BID C1872C WATER CONSERVATION & LANDSCAPE PROJECT AT THE LIBERAL ARTS CAMPUS

ADDENDUM NO. 4

May 22, 2018

LANDSCAPE
DEMOLITION PLAN

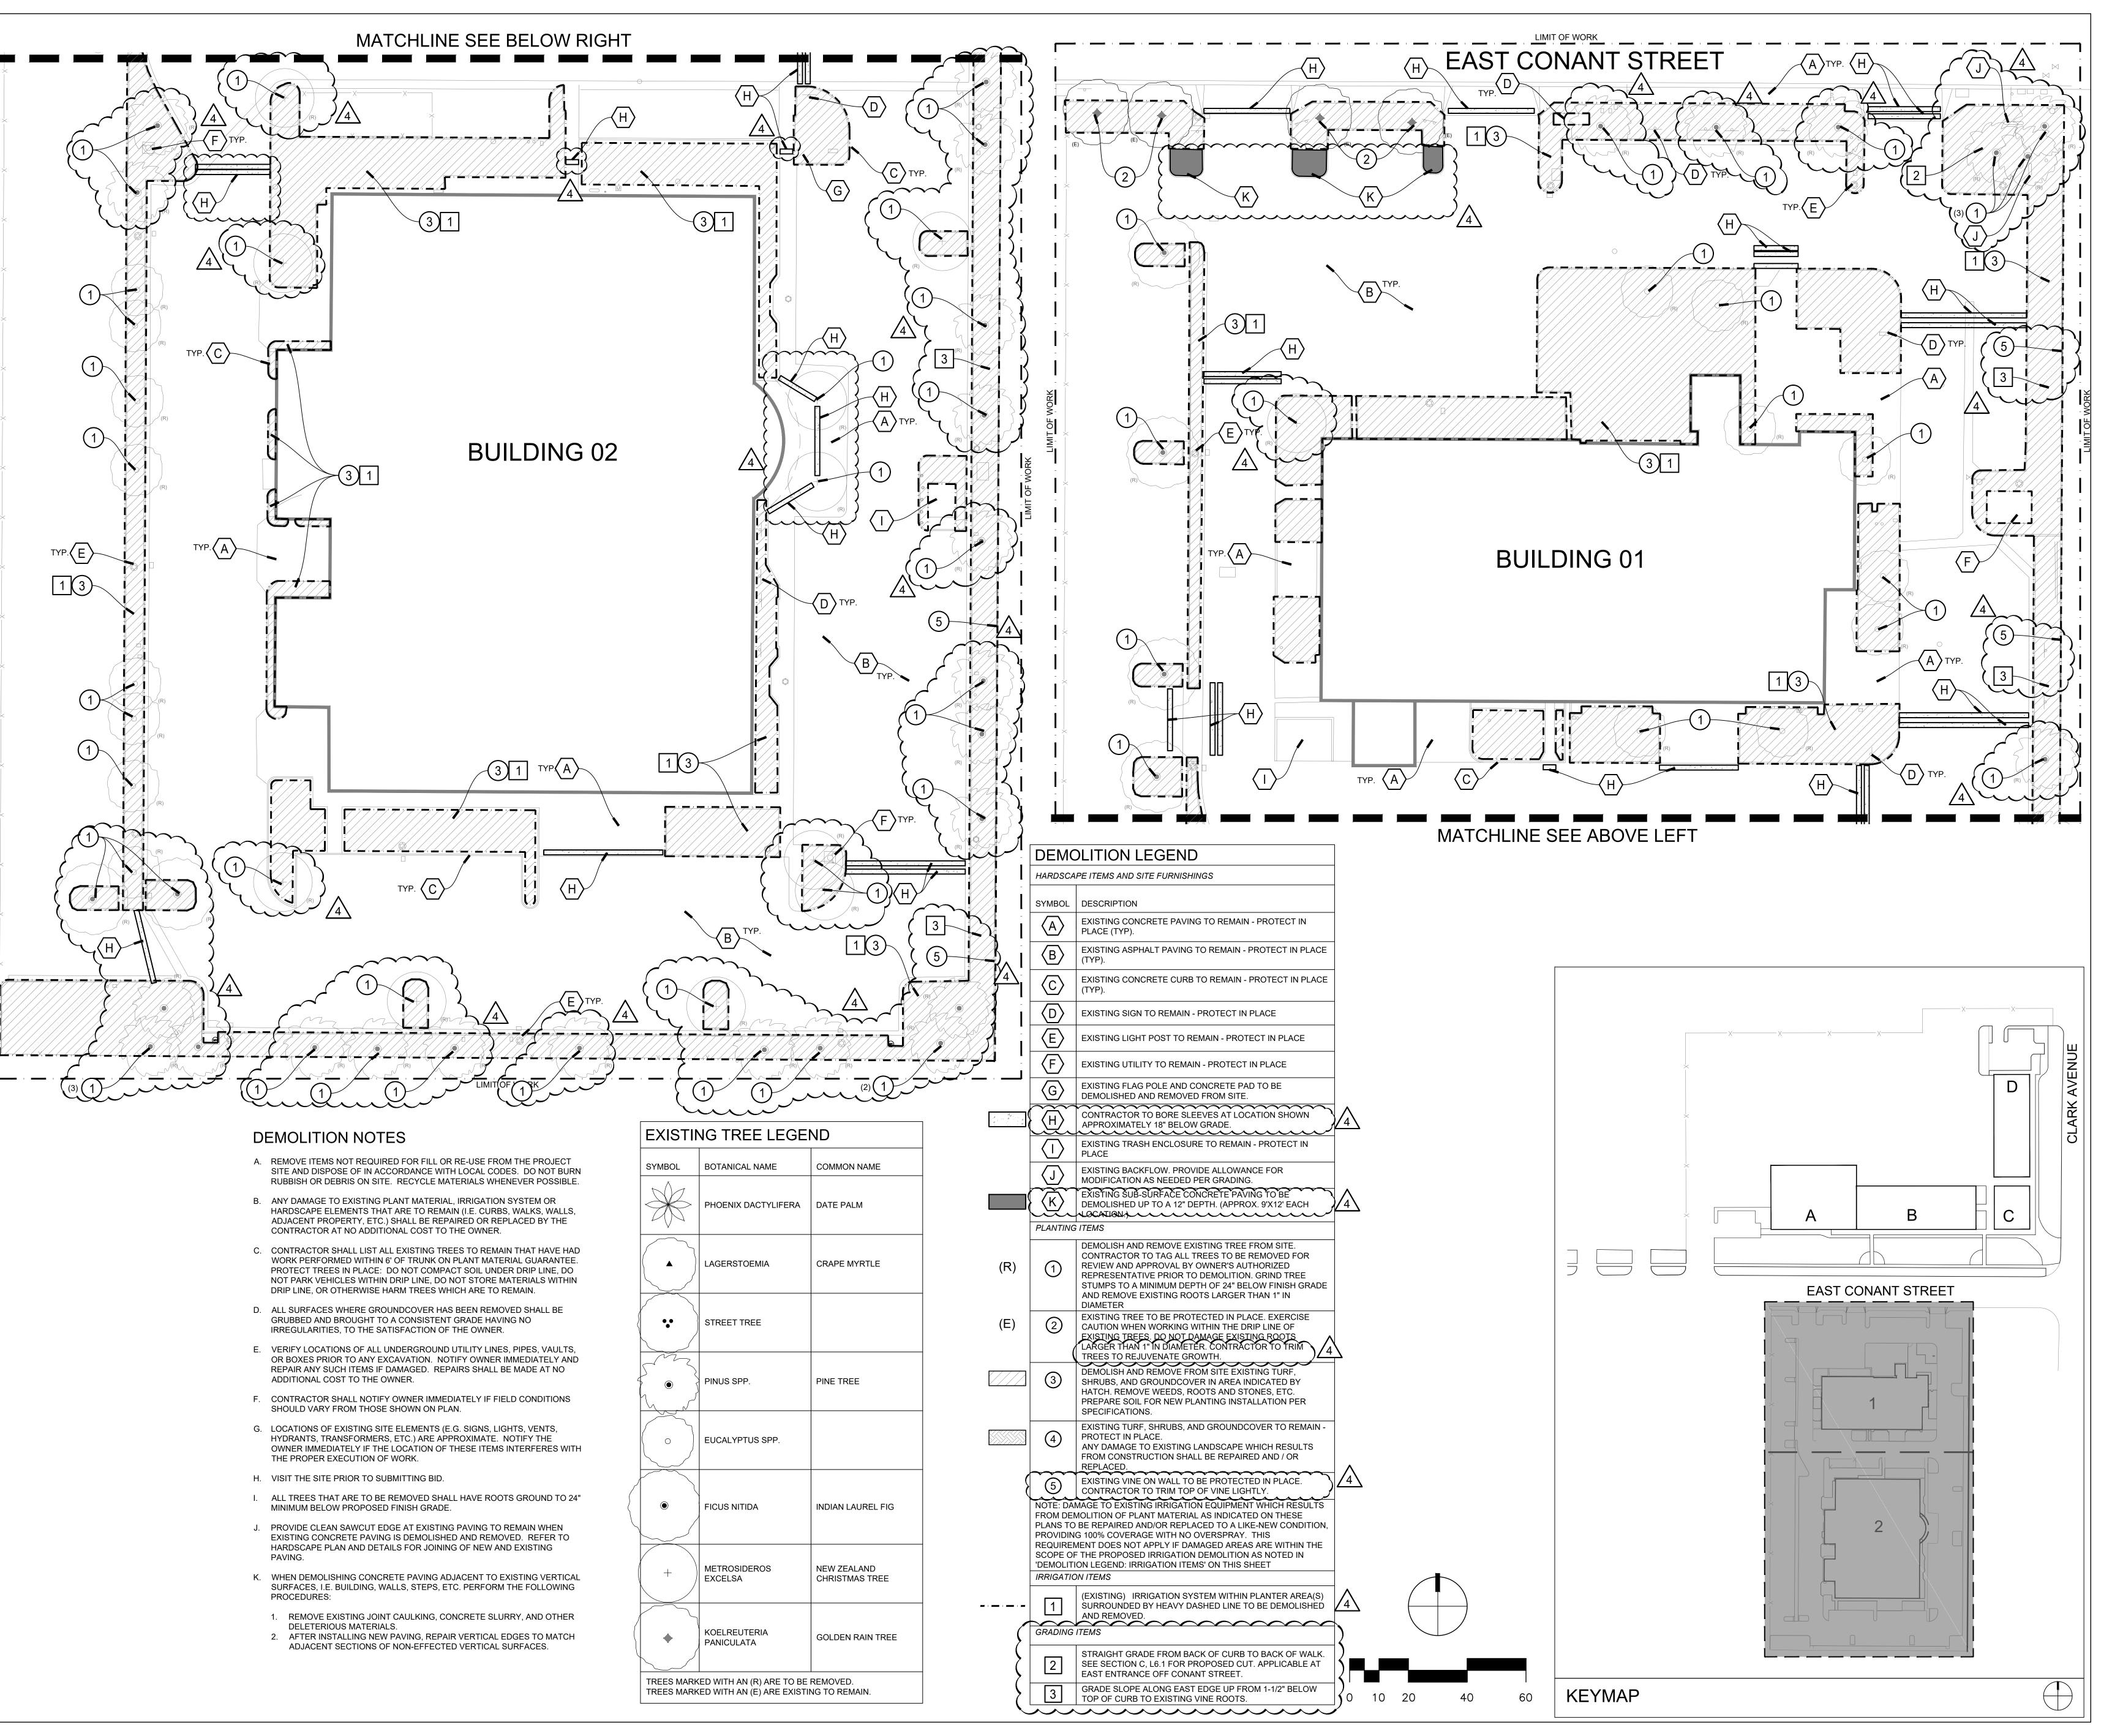
- 1. Plans L1.1; L1.2; L2.1; L2.2; L2.3; L3.1; L3.2; L4.1; L4.2: L5.1 and L 6.1 have been updated with increased amount of tree demolition, addition of new trees, and all associated irrigation.
- 2. Union fittings added to all valve boxes.
- 3. Increased work boundary to include the east side of Building Z.
- 4. Commscope certified contractor to provide and install CAT-6 data wiring from IDF rooms to irrigation controllers. Commscope certified contractor also to provide and install all data wiring in ³/₄ inch conduits.
